SERVICE LETTER NUMBER 138			
10000 and 13000 Nose Gear End Cap Cracks			
BY: MAB	AIRCRAFT	FLOAT MODEL(S):	NOTE(S):
APP: SDW	MAKE/MODEL(S):	10000A	MANDATORY
DATE: 10/22/2019	FIREBOSS 802/802A	13000A	COMPLIANCE
REV: D	VIKING DHC-6		S.L. P/N 1003610

FAA APPROVAL HAS BEEN OBTAINED FOR TECHNICAL DATA IN THIS PUBLICATION THAT AFFECTS STC OR TSO DESIGN COMPLIANCE.

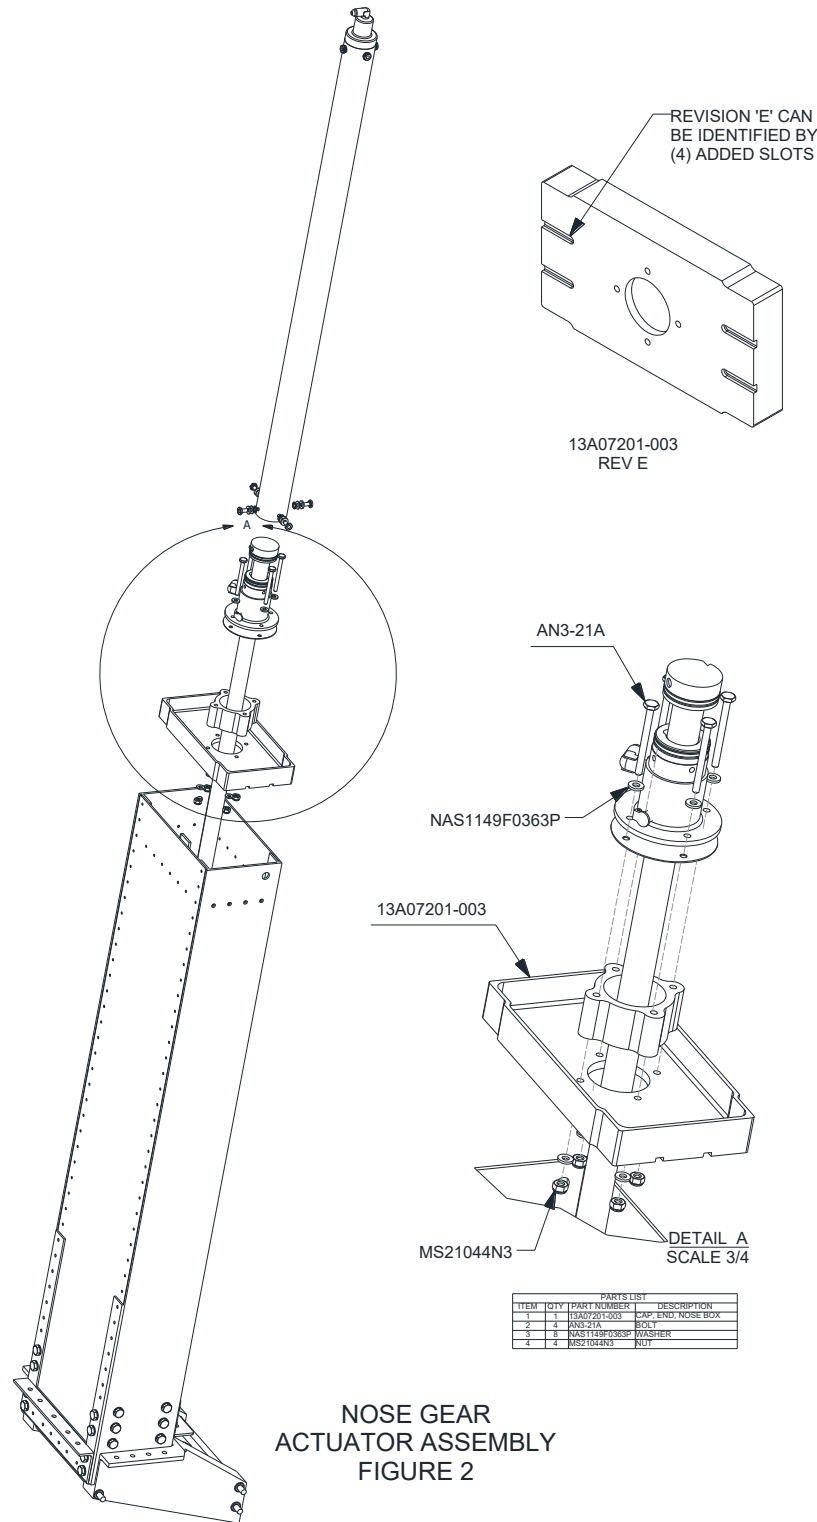
Several Nose Gear Box End Caps, part #13A07201-003 have been found to have cracks propagating from around the Cylinder Mounting Flange bolts (4). If these cracks go undetected there is a possibility that the End Cap, Part #13A07201-003 can break and let the actuator cylinder move to a selected gear position without actuating the gear properly. This condition could potentially lead to a gear indication suggesting that a selected nose gear position has been reached, when it has not.

A close visual inspection must be accomplished within the next 25 hours of operation, and every 50 hours thereafter. The cracks will be best visible by looking at the forward face of the End Cap, Part #13A07201-003 through the forward open end of the Nose Gear Box. It appears that the cracks start just above the top mounting bolt and just below the bottom mounting bolt as shown in Figure 1. If cracks are found, the End Cap Part #13A07201-003 must be replaced with the new revision, End Cap, Part #13A07201-003, Revision E, dated October 2nd, 2012 or later. In addition, replace the (4) AN3-20A mounting bolts with (4) AN3-21A bolts. After inspection and/or replacement, re-adjust the gear “down” over-center lock so that it hits the end of the lock-up track and has little to no preload pressure, since the preload pressure would cause extra stress at the Cylinder Mounting Flange and the End Cap.

NOTES: Figure 1 shows the part that is cracked, and figure 2 shows its location on the nose box assembly. This is the forward side of the part which can be seen looking into the open (front) end of the nose gear box. No disassembly should be required to examine this area. The area should be thoroughly cleaned before inspecting. Use good lighting. If in doubt, dye penetrant inspection can also be accomplished.

Replacement of the older revision parts with revision E parts will eliminate the requirement for 50 hour interval inspections, but this inspection should still be accomplished at 100 hour intervals thereafter. Revision E parts can be identified by (4) added slots as shown in Figure 2.

If evidence of cracking is found in Nose Box End Cap either by visual or dye penetrant inspection per figure 1, the following instructions will be accomplished to replace damaged Nose Box End Cap:
